Delegated Report

Householder Planning Application

Planning Application No: 20240734

Description: Formation of a vehicular access, engineering operation, including new steps and new retaining wall, to facilitate hardstanding area.

Proposed Development

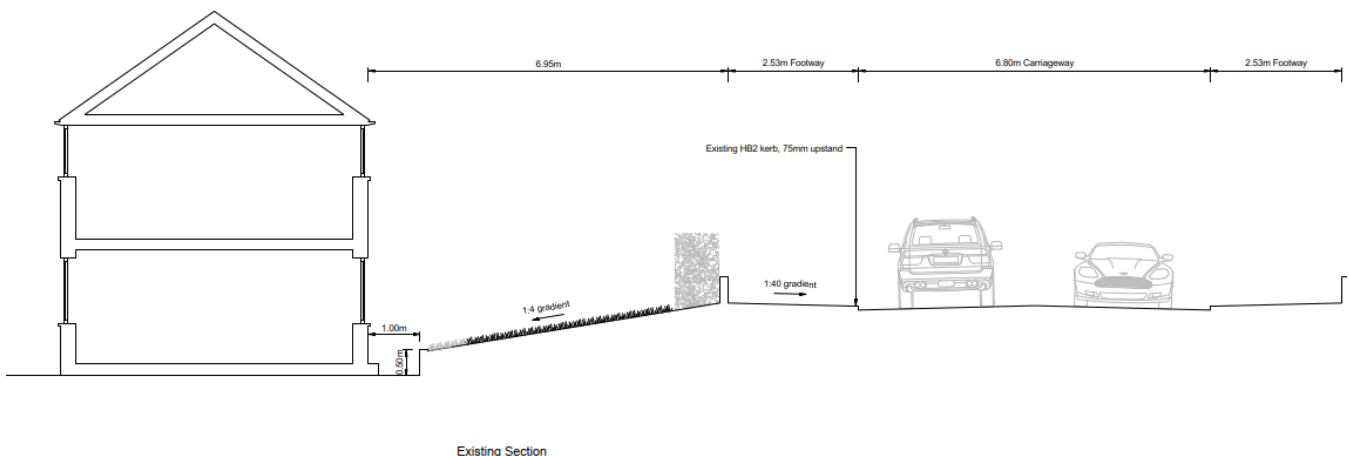
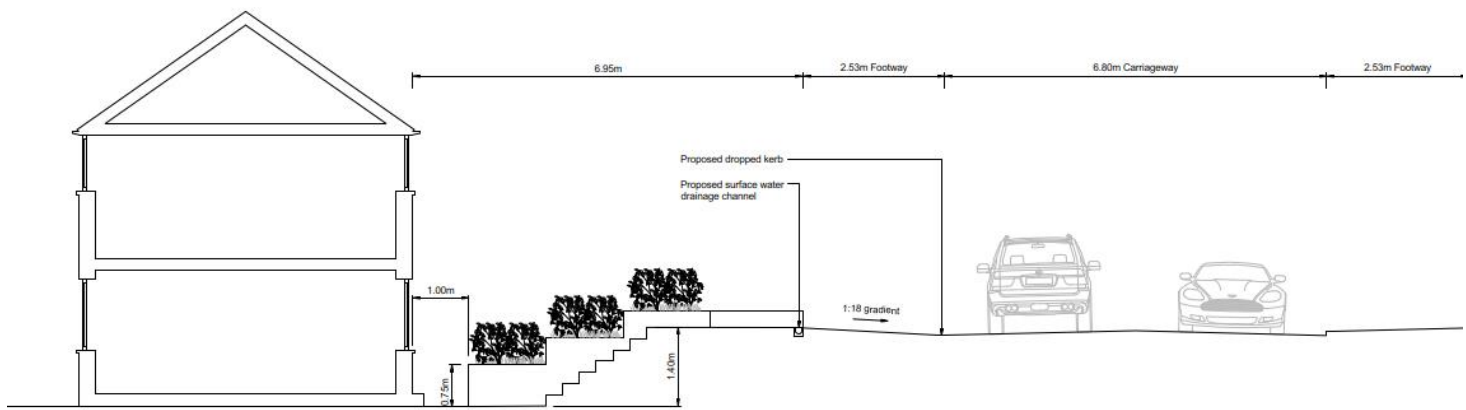
The plans indicate development would create space for three cars and proposes to include three tiered planters. The existing grass lawn, hedging and dwarf wall would be lost as a result of the development.

Proposed Section

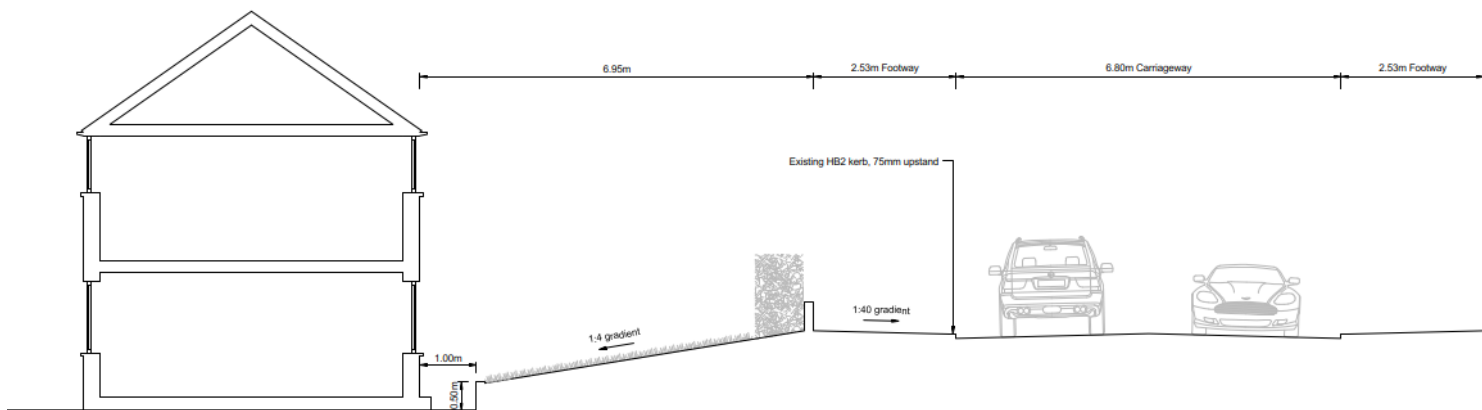
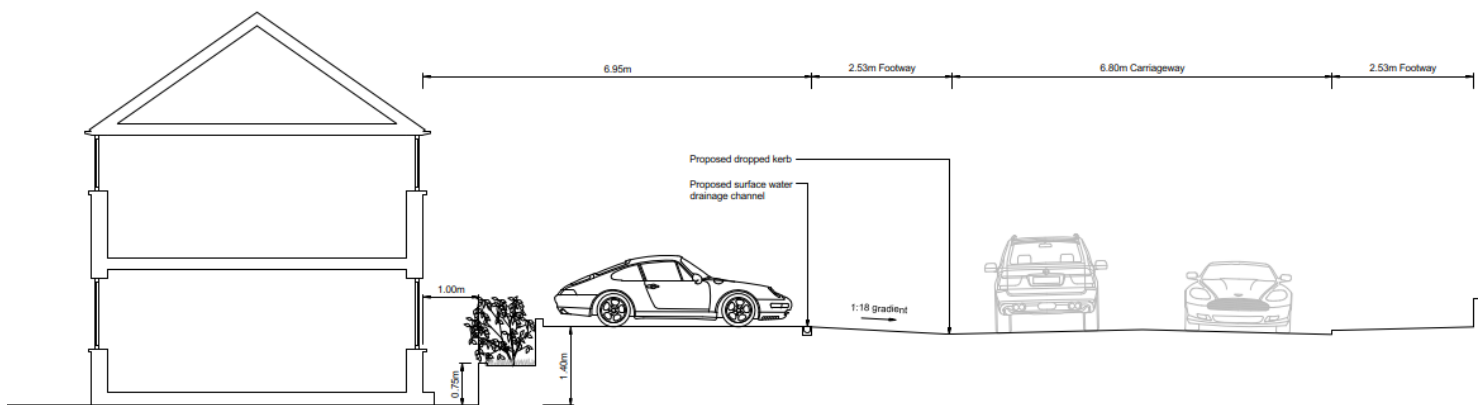
The submitted plans do not accord with the principles of the Design Guidance (2021). The proposal would result in the complete loss of the grass lawn, established hedging and dwarf wall, which contributes positively to the main dwelling and street scene, as aforementioned above. Furthermore, the proposal would result in engineering works, hardstanding and hard landscaping that would significantly cover the existing soft landscaped garden. It is noted that the proposal does include three tiered planters, however, this is minimal and is not considered to mitigate the harm caused by this proposal. The expanse of three parking spaces appear excessive for this semi-detached property, and remove the opportunity to retain more soft landscaping to soften the appearance of the development. In addition, it is noted that the bins are currently stored on the lawn area, it is unclear where the bins would be stored, post development.

Materials

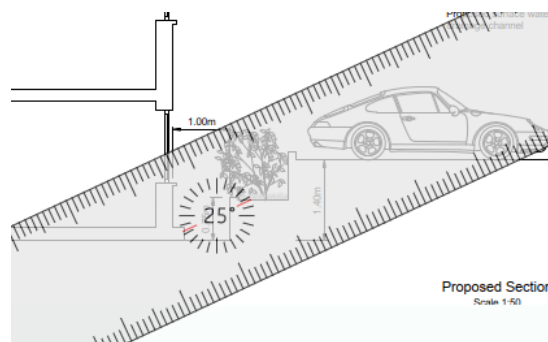
The hardstanding area would be constructed using block paving, which could be conditioned to ensure it would be permeable and appropriate. The proposed planters and retaining walls would be constructed using reinforced concrete blocks with a white rendered finish. This is considered to be poor design and would not be sympathetic to the existing dwelling, nor would it contribute positively to the street scene. As established by the Planning Inspector for a dismissed appeal at 80 St Hildas Way, Gravesend (reference

APP/K2230/D/19/3226128), whereby similar materials were proposed, the Inspector stated, *'the breeze block supporting wall surrounding the driveway is, in its current form, unattractive and visually obtrusive in the street scene and has a harmful effect on the character and appearance of the area. The Inspector goes on to say, 'Due to the difference in levels between the road and the houses, there are many examples of retaining walls surrounding driveways in the immediate area. Whilst some of these are similarly harmful to the street scene, the majority are formed by brick walls, or blocks capped with bricks or stone which are generally more appropriate in appearance within a residential area. I note the appellant's comments that the materials and final finish of the proposed development could be dealt with by condition. However, in the absence of any details before me, I cannot be sure that a satisfactory external appearance could be adequately controlled and secured by way of a planning condition. The proposal would have a harmful effect on the character and appearance of the area and as such would be contrary to Policy CS19 of the Gravesham Local Plan Core Strategy (September 2014) which requires new development to be visually attractive, fit for purpose and locally distinctive and to make a positive contribution to the street scene, public realm and the character of the area. It would also conflict with the National Planning Policy Framework (2019) as it would not add to the overall quality of the area.'* As such, the proposal, as submitted is considered harmful to the character and appearance of the host dwelling and area.

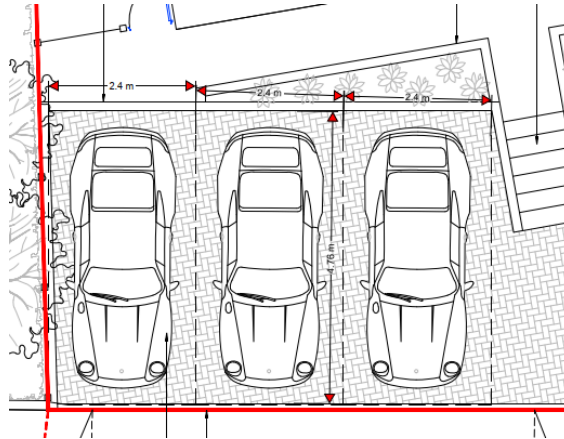
The plans show that the proposed parking areas would be 2.40m (width) x 4.76m (depth).

This is contrary to the requirements set out in SPG 4 - KCC Parking Standards (2006) and Gravesham's Householder Extensions/Alterations Design Guide (2021), which state car parking spaces need to be a minimum of 2.50m wide (2.7m where spaces adjoin an enclosed boundary) and 5.00m deep. As such, the spaces are substandard and the hardstanding area cannot provide space for three cars. In addition, the retaining wall directly behind the spaces is very low:

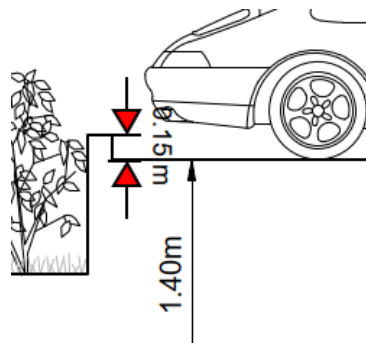
Furthermore, no visibility splays have been provided. To ensure highway safety, driveway design should incorporate 2.00m x 2.00m visibility splays on either side, with any hard or soft landscaping limited to 0.60m in height. Although the soft and hard landscaping within neighbouring properties is outside of the control of this application, it is considered that it may be possible to achieve the required visibility via amendments and redesign. However, given the other issues raised above, this would not constitute a small amendment and as such, the application should be determined as submitted.
